BRITISH RAILWAYS WESTERN REGION

SIMPLIFICATION OF LAYOUT AND SIGNALLING—CENTRAL WALES LINE

SIMPLIFICATION OF SIGNALLING—CENTRAL WALES LINE

I have received copy/copies of Notice No. W.W. 206, dated 1st December, 1965.

SKETCH I

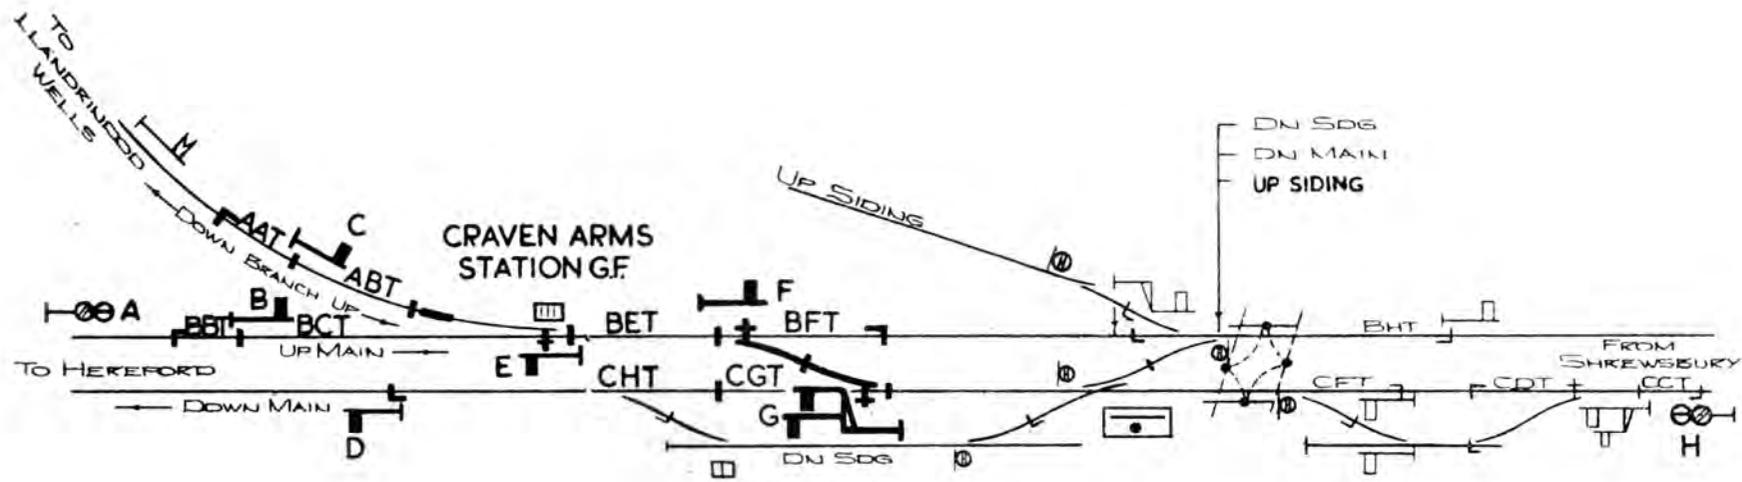
AT CRAVEN ARMS CROSSING (Sketch 1)

Form	Description	Position	Distance from Signal Box
A 	Up Main Distant The height of the new	Up side of Up Main Line signal will be 12ft. 0 in.	2,984 yds.
B 	Up Main Home The height of the new	Up side of Up Main Line signal will be 18ft. 0 in.	1,211 yds.
C 	Up Branch Home The height of the new	Up side of Up and Down Branch Line signal will be 18ft. 0 in.	1,213 yds.
D 	Down Main Advanced starting The height of the new	Down side of Down Main Line signal will be 18ft. 0 in.	821 yds.

Form	Description	Position	Distance from Signal Box
	Up Main Intermediate Home The height of the new	Up side of Up Main Line signal will be 18ft. 0 in.	355 yds.
	1. Down Main Starting 2. Down Main Starting to Up Main The height of the new	Down side of Down Siding signal will be 24ft. 9 in.	270 yds.
	Down Main Distant The height of the new	Down side of Down Main Line signal will be 12ft. 0 in.	2,840 yds.

The existing Up Branch Distant for Craven Arms Junction signal box will become the Up Branch Distant for Craven Arms Crossing signal box.

The disc routed from Up Main to Down Sidings or Down Main will additionally be routed to Up Siding and will exhibit a red arm and light.

The Down Main Inner Home will be renewed on the same site at a reduced height of 18ft. 0in.

The existing Up Main Home will be renamed "Up Main Inner Home."

- Up Main Distant
- Up Main Inner Distant
- Up Main Inner Distant Banner Repeater
- Up Branch to Up Main Distant
- Down Main Distant
- Disc reading from Up Main to Up Sidings

New connections will be **brought into use** in accordance with attached Sketch I.

A new 3-lever ground frame, to be known as "Craven Arms Station Ground Frame," will be **brought into use** at approximately 20m. 1ch., situated at the Hereford end of Up Main Platform, operating the spring slotted facing connection and signal (E) from Up Main to Branch. The signal will be situated on the Up side of the Up Main line, adjacent to the Ground Frame at a height of 18ft. 0in. The new ground frame will be released by key from release instrument controlled by control instrument in the signal box. A telephone will be provided.

SKETCH 2.

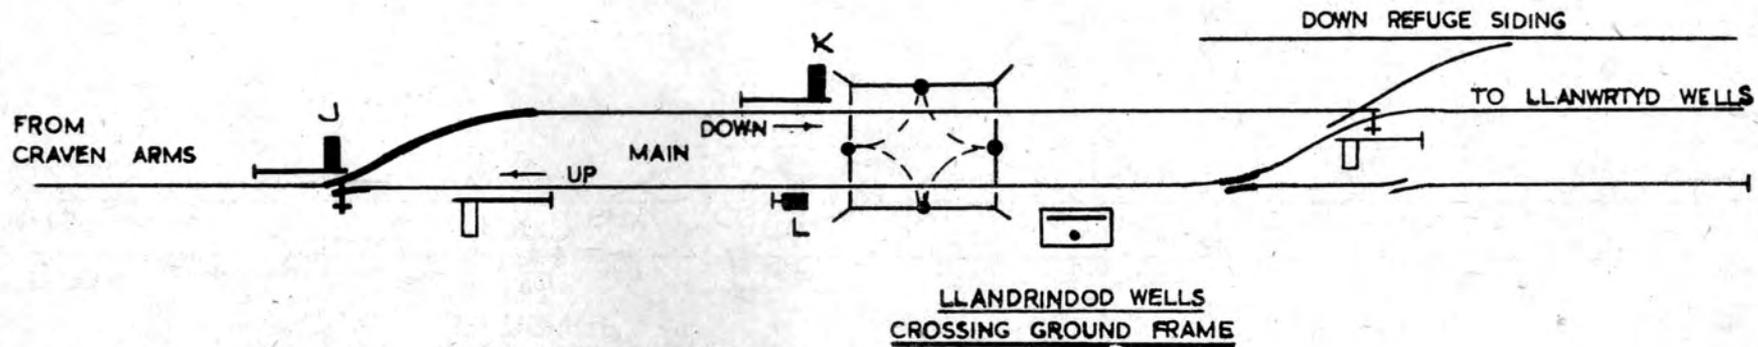
At Llandrindod Wells (Sketch 2)

The signal box will be reduced in status to a Ground Frame and named "Llandrindod Wells Crossing Ground Frame."

Form	Description	Position	Distance from Signal Box
	Down Main Home The height of the new	Down side of single line signal will be 18ft. 0 in.	305 yds.
	Down Main Inner Home The height of the new	Down side of Down Main line signal will be 18ft. 0 in.	20 yds.

A new stop lamp (L) will be provided in accordance with Sketch 2.

A new connection will be **brought into use** in accordance with attached Sketch 2.
